**REF. NO. 166
POWER STEERING
SYSTEM**

550 MARANELLO

INTRODUCTION : Ferrari 550 Maranello Power Steering System

INSTRUCTIONS FOR POWER STEERING UPDATE KIT REPLACEMENT

Figure 1

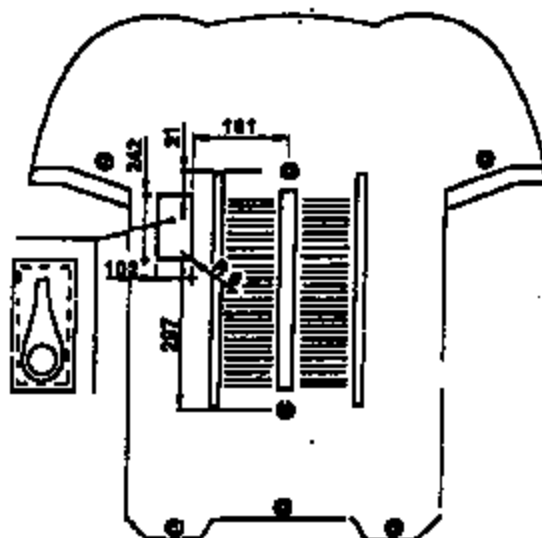
- 1) Remove the front part of the underpanel and suitable modify it with the kit part number 65895400 according to the measurements shown in figure 1.
- 2) Drain the hydraulic oil from the system by removing the pipes 11 and 16 of the power steering pump shown in figure 3.
- 3) During draining, remove the air flow duct from the water/oil radiator in the engine compartment number 46 as shown in figure 2.

Figure 2

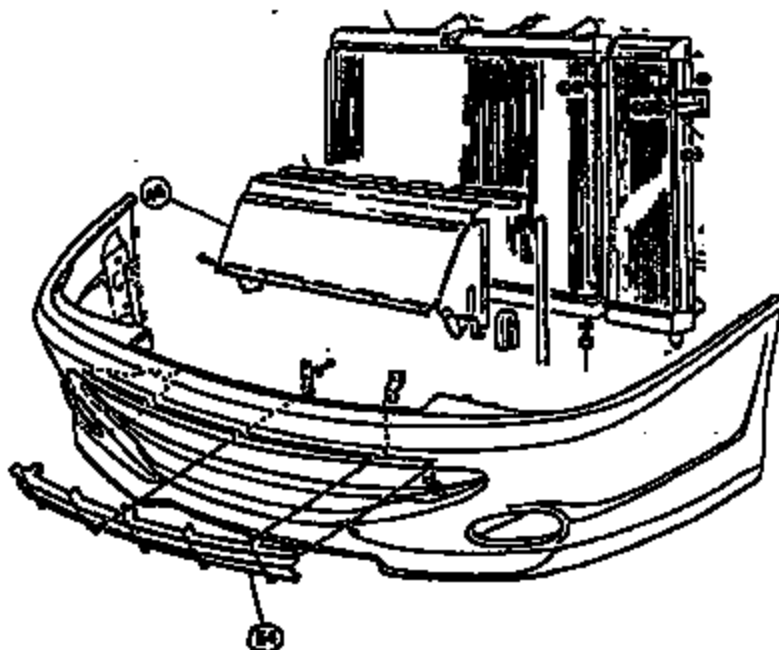
- 5) Remove the grill from the front bumper item 54 in figure 2.
- 6) Remove the old cooling coil part number 170856 and install the new cooling coil part number 177360.

Figure

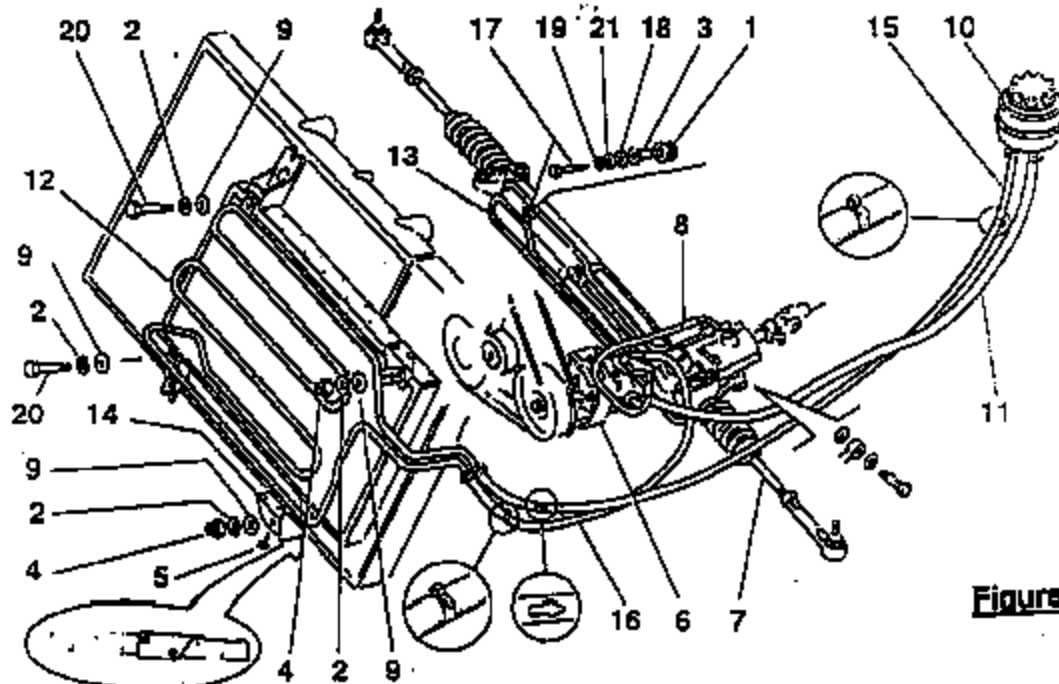
- 7) Remove the old power steering oil tank and install the new power steering oil tank supplied in the kit.
- 8) Remove the old oil supply lines and install the new oil supply lines as shown as items 11 and 15 in figure 3.

- 9) Remove the complete steering box/cooling coil pipe item 16 from the pipe 13 at the steering box outlet as shown in figure 3.
- 10) Remove and space the steering box from the chassis to disassemble the pipe 8 as shown in figure 3.

- 13) Fit the new pipe 8 on the new steering box and tighten the coupling to the torque of 25 Nm.
- 14) Fit the pipe 13 to the new steering box to ensure that the outlet banjo bolt can be fitted without interference. Remove the pipe 13 from the steering box.

- 15) Install the new steering box on the chassis replacing the relevant fastening nuts.
- 16) Install the new pipe 13 on the steering box outlet.
- 17) Connect the pipes 8 and 11 to the power steering pump.

- 18) Install the new pipe 16 connecting it to the power steering pump and to the cooling coil.
- 19) Fill the system completely with new oil according to the prescriptions (Shell Donax TA)
